**Response to EIS – Atlassian Office and Hostel Development – SSD 10405**

Thank you for your correspondence dated 10 December 2020 seeking comment on the EIS for the Atlassian office and YHA hostel development at 8-10 Lee Street, Haymarket. City staff have reviewed the EIS and provide the following feedback.

### **Minor overshadowing of Prince Alfred Park**

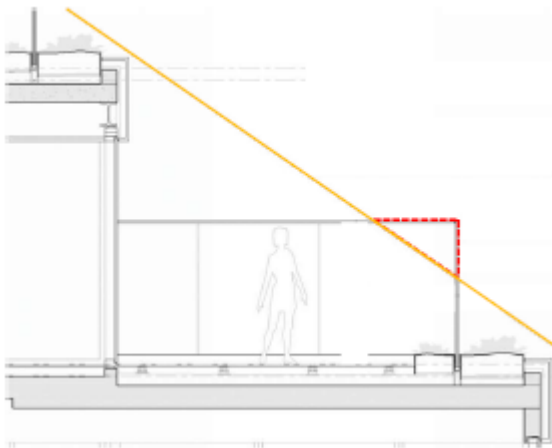
1. This is avoidable and can be fixed. The development overshadows Prince Alfred Park by way of high glass balustrading to the roof terraces. The sun access plane forms part of the Central Sydney Planning Strategy sets the limit for overshadowing over the park.
2. The City strongly objects to this overshadowing beyond the limit - it breaches the sun access plane to the park. This has previously been brought to the applicant's attention and is easily remedied. The section below shows the extent of balustrade which causes the impact. Reducing the extent of private terrace footprint and height of glazing (and its structural support) will remove the impact completely and comply with the limit of allowable shadow. The Department should avoid a precedent for future development at Central Station and enforce compliance with the sun access plane.

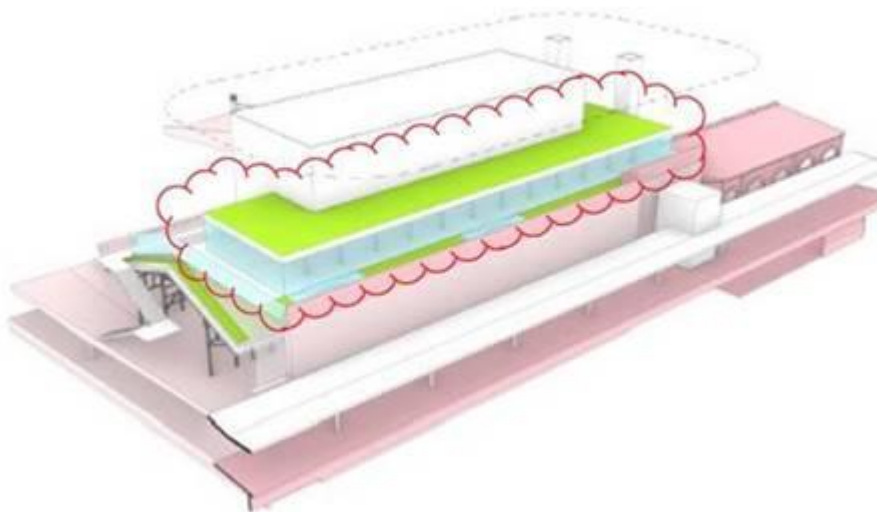
3. A significant amount of Exceptional and High Significance elements is proposed to be demolished and some to be removed and re-assembled should be minimised.
4. The roof garden and stepped seating structure on the roof are not considered sympathetic to the scheme and should be avoided. The simpler metal roofing is recommended to be maintained for visual separation with the new structure. We

are concerned that the proposed green roof is on a cantilevered section of the heritage roof and could not be adequately supported by the existing structure. It would require additional major steel structural elements to support it. Given the nature of the expressed timber structure in the underside of the parcels shed roof, any additional structure will be visible and will compromise the integrity and appearance of the reconstructed timber structure. For similar reasons and further discussed regarding other issues, the proposed bleacher seating has an unnecessary visual imposition and affects the structural integrity of the heritage item. For these reasons it is not supported.

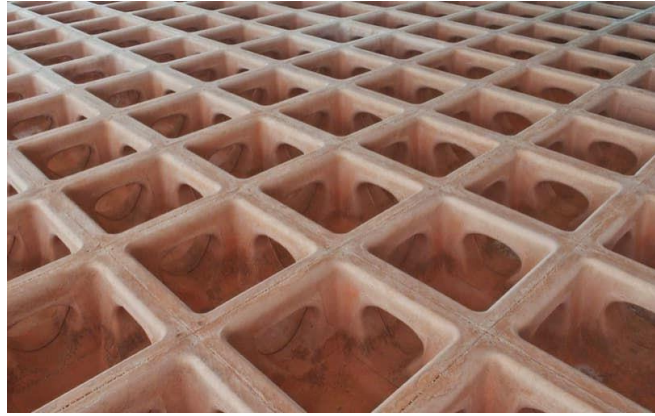
25. The following recommendations are made with respect to the BiPV system:
  - Submit photographic evidence and confirm locations where this BiPV glazing system has been built with planting at the edge in Sydney or a warm temperate climatic zone.

- Build off site in Sydney a full-sized prototype for the BiPV façade with planting in the habitat and tested off site located in a west facing aspect.

- Submit empirical evidence gathered from testing the prototype to confirm feasibility of the glazing solar system, natural ventilation and how impacts on proposed planting within Habitat levels will be mitigated.
- The City understands a similar condition was applied by DPIE to the Lend Lease development Damaru House Barangaroo (1 Sussex Street) that includes an integrated green roof with solar panels over a CLT commercial building. DPIE required empirical evidence and ongoing research data collected to demonstrate the energy captured, energy costs and temperature reduction, and success of an integrated green roof with PV cells.
